Location Address: 2328 JACKSON ST, HOLLYWOOD FL 33020
Lot(s): 13 Block(s): 4 Subdivision: HOLLYWOOD LITTLE RANCHES

Explanation of Request: NEW CONSTRUCTION 33 UNIT RENTAL APARTMENT BUILDING

SUBJECT: Preliminary Site Plan and Design review for 33 Residential Units.

SCALE: 1"=40'

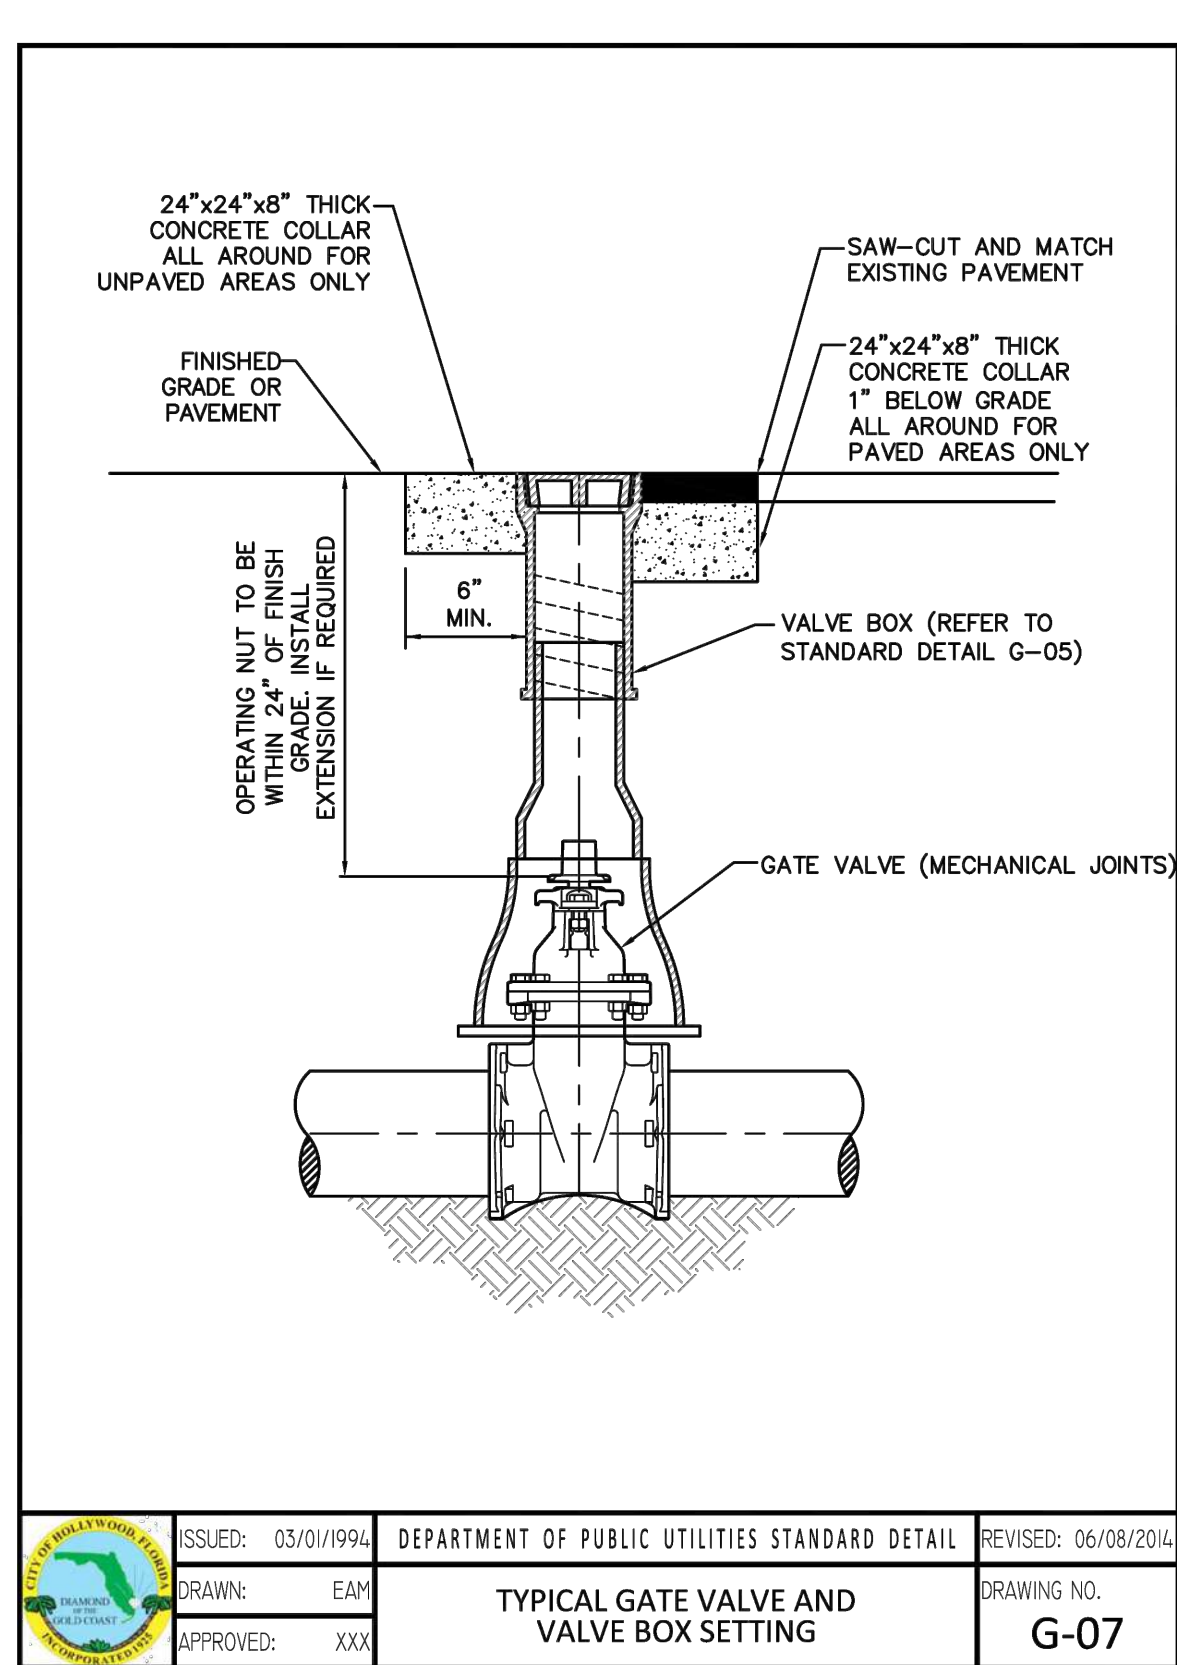
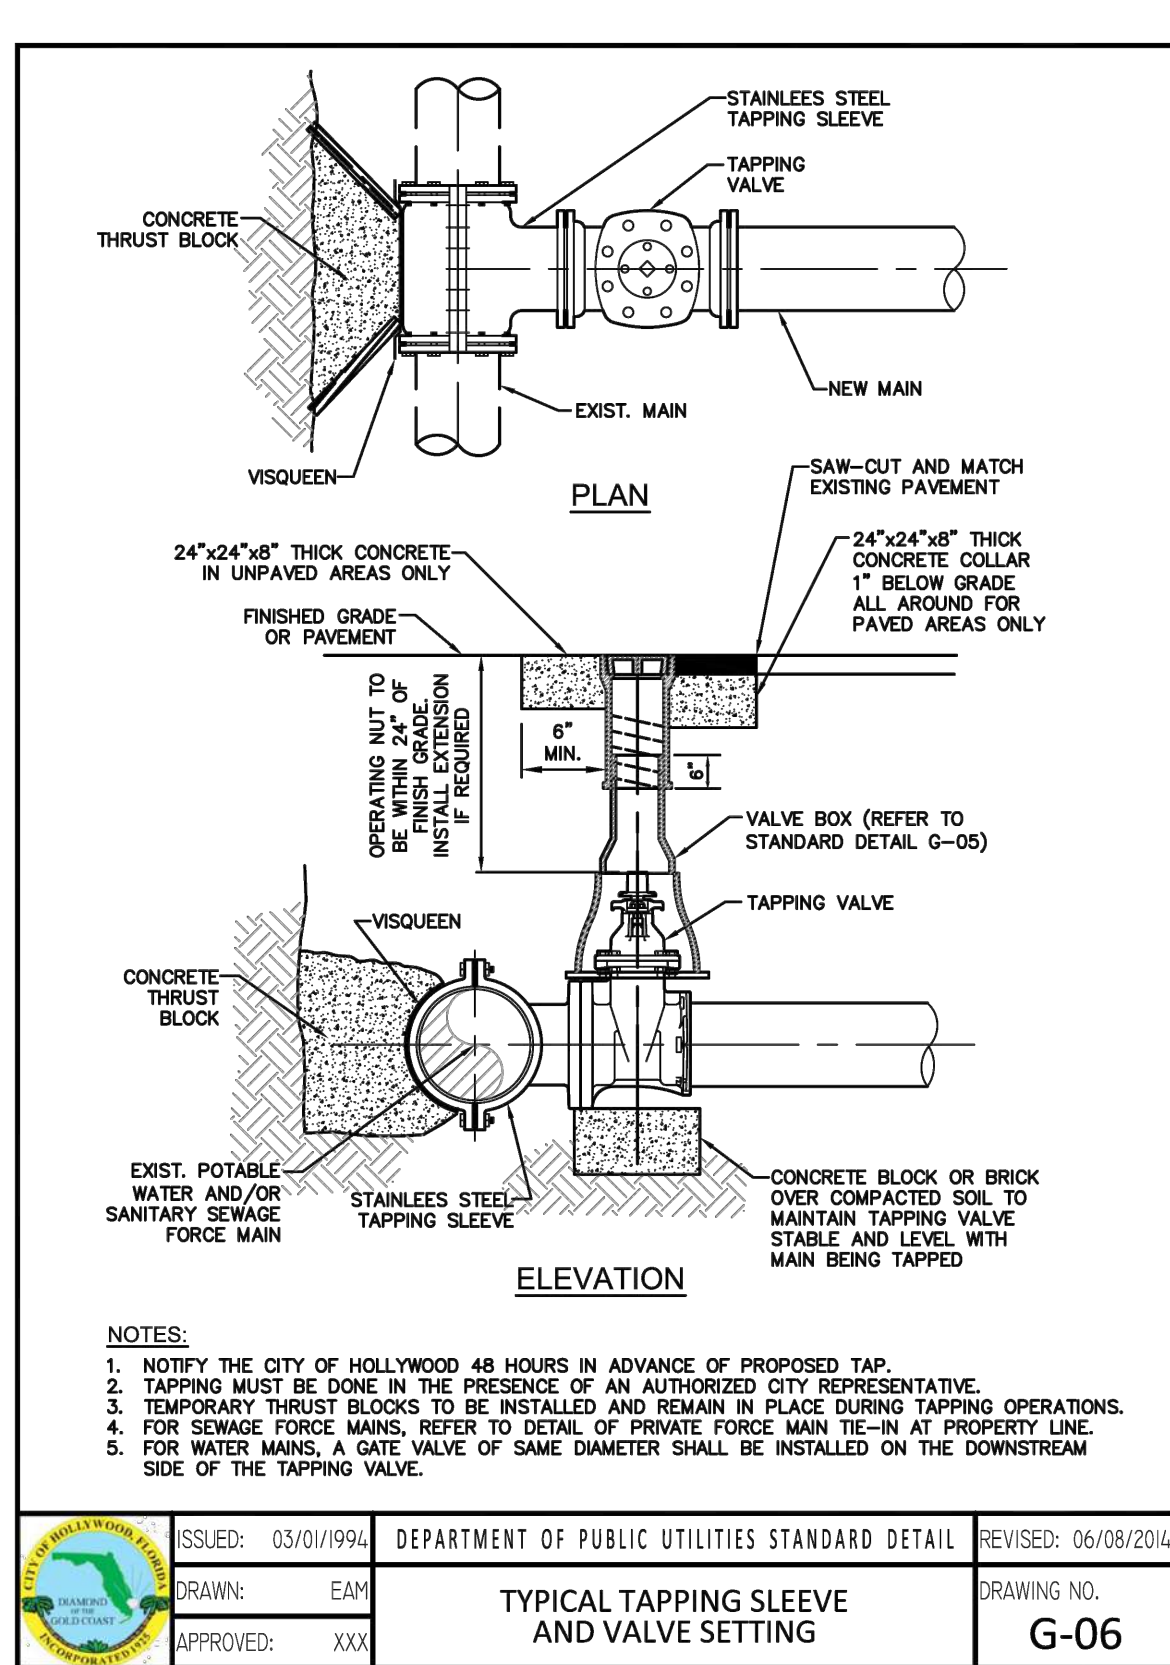
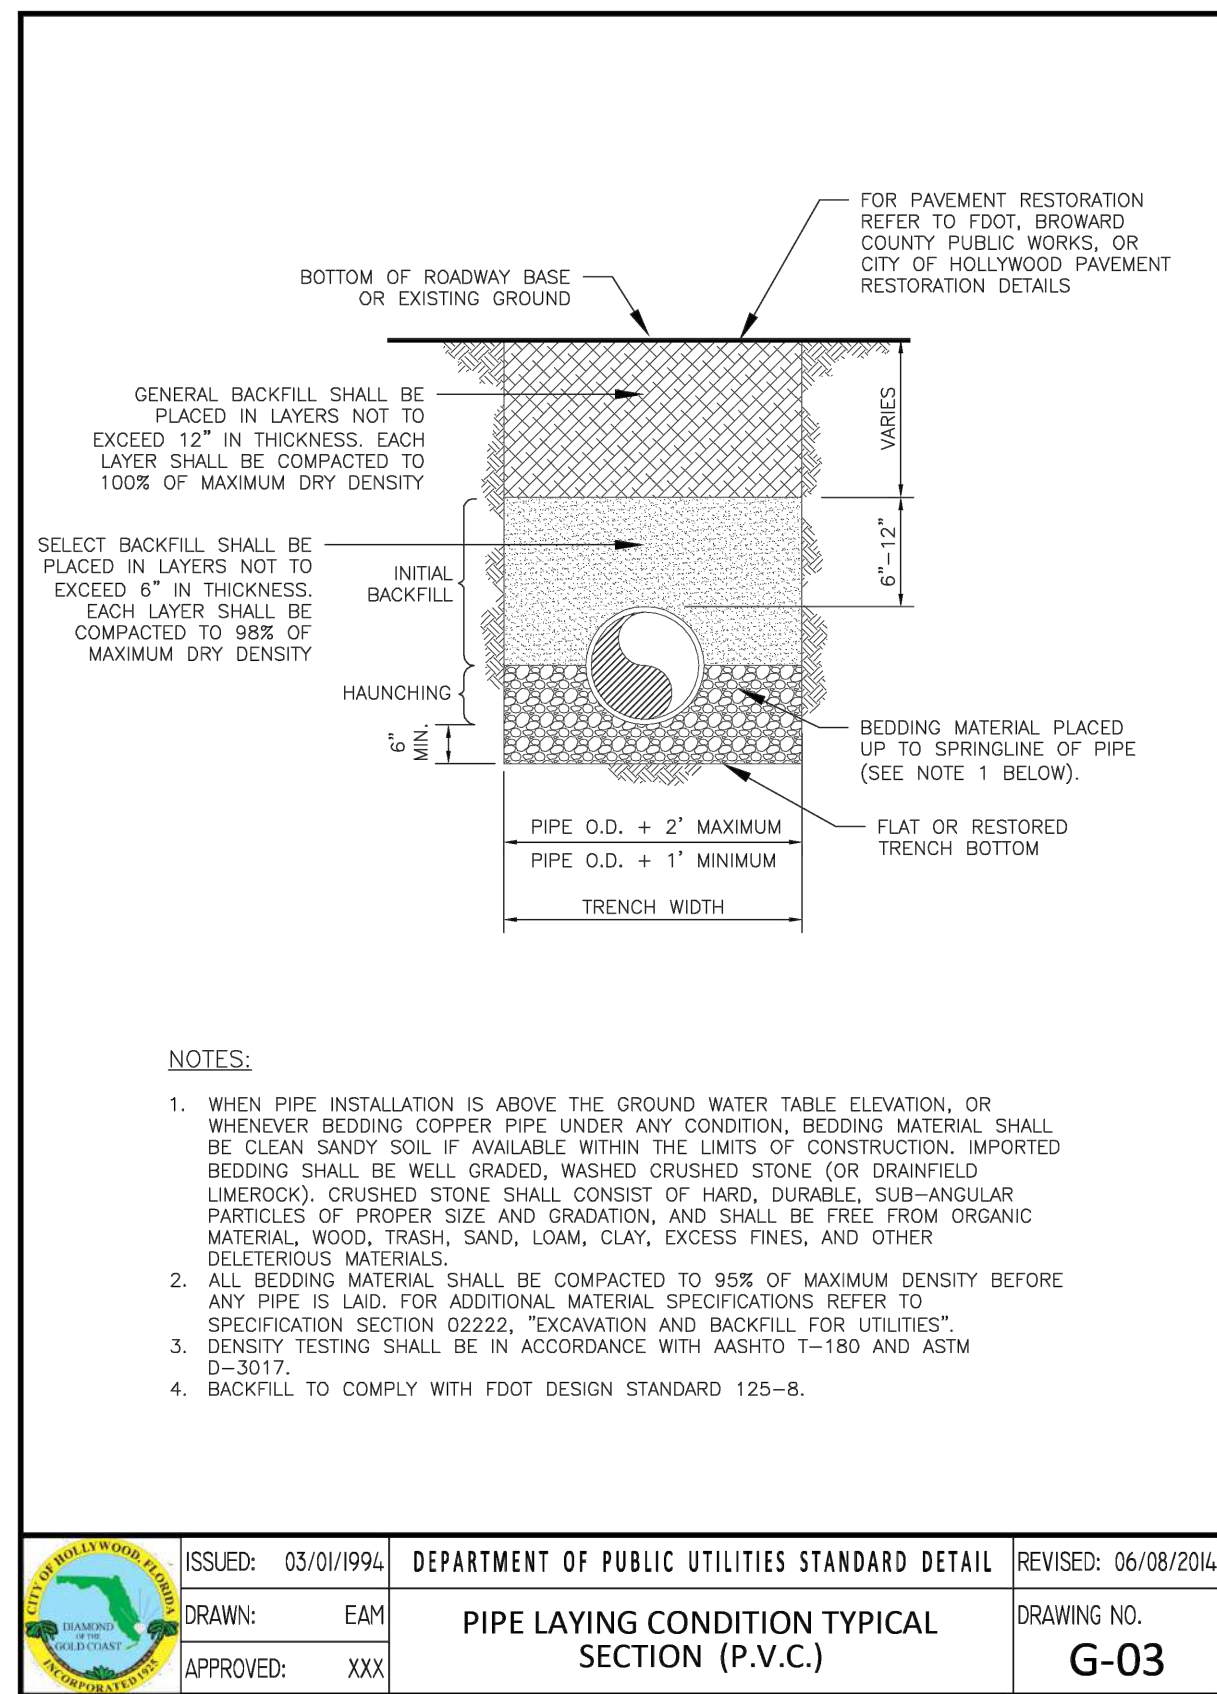
2. Provide civil drawings for the underground fire main. --- Provide such including the location of the fire department connection, DDCV, and size and type of the fire line from the water supply. --- Check with our water department for city requirements in addition to fire. --- Ensure on the plans that there is a fire hydrant within 100 feet of fire department connections as required by NFPA 14 (2016 Ed.) Section 6.4.5.4 --- "Fire department connections shall be located not more than 100 ft (30.5 m) from the nearest fire hydrant connected to an approved water supply."

3. Provide a note on civil drawing all underground fire main work must be completed by fire protection contractor holding a Class I, II, or V license per FS 633.102.

4. Water supply and any new hydrants shall be in place prior to accumulation of combustible materials per NFPA 1 (2018 Ed.) Section 16.4.3.1.1. --- Provide a note on the plans.

RESPONSE: Please see sheet C6.

RESPONSE: Please see note on sheet C6.

RESPONSE: Please see note on sheet C6.
